UNITED STATES PATENT AND TRADEMARK OFFICE

APPLICATION NO.	FILING DATE	FIRST NAMED INVENTOR	ATTORNEY DOCKET NO.	CONFIRMATION NO.
10/576,560	11/06/2006	Olle Hemmingson	1000500-000385	3806
21839 7590 03/31/2009 BUCHANAN, INGERSOLL & ROONEY PC POST OFFICE BOX 1404 ALEXANDRIA, VA 22313-1404				
EXAMINER				
PATEL, BHARAT C				
ART UNIT		PAPER NUMBER		
3724				
NOTIFICATION DATE		DELIVERY MODE		
03/31/2009		ELECTRONIC

Office Action Summary

DETAILED ACTION

FIG. 5

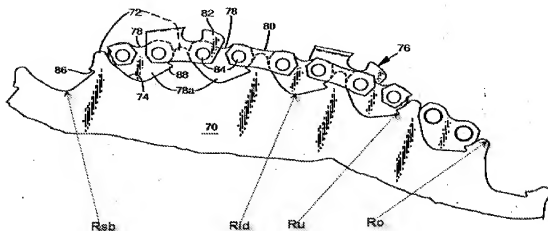
Re claim 2, Carlton discloses that the cam surface 88 on each driving link 78 is designed to press the chain 76 radially outwards against the radial projection 86 by the

cam effect, in such a way that, in a tensioned state, the chain is held onto the disk 70 as a result of its shape per Fig. 5 and per col. 4, lines 3-36.

Re claim 4, Carlton discloses that the bottom 74 of the groove has a predetermined number of projections 86 distributed evenly around the circumference of the disk 70 per Fig. 5.

Re claim 5, Carlton discloses that the bottom 74 of the groove has one projection 86 for each driving link 78 per Fig. 5.

Re claim 6, Carlton discloses that radial cross-section of each projection 86 is lug shaped per Fig. 5.

Re claim 7, Carlton discloses that radial cross-section of each projection 86 is pyramid shaped per Fig. 5.

Re claim 8, Carlton discloses that radial cross-section of each projection 86 is dome shaped per Fig. 5.

Re claim 9, Carlton discloses that radial cross-section of each projection 86 is designed as a truncated cone that has a complementary shape to the cam surface 78a of the interacting driving link 78 per Fig. 5.

Re claim 11, as best understood, Carlton discloses that the construction of the chain 76 is such that the connecting links 80 are spaced radially outwardly with respect to radially outermost portions of the radial projections 86 when the chain is in a neutral position and when the chain is being driven per Fig. 5.
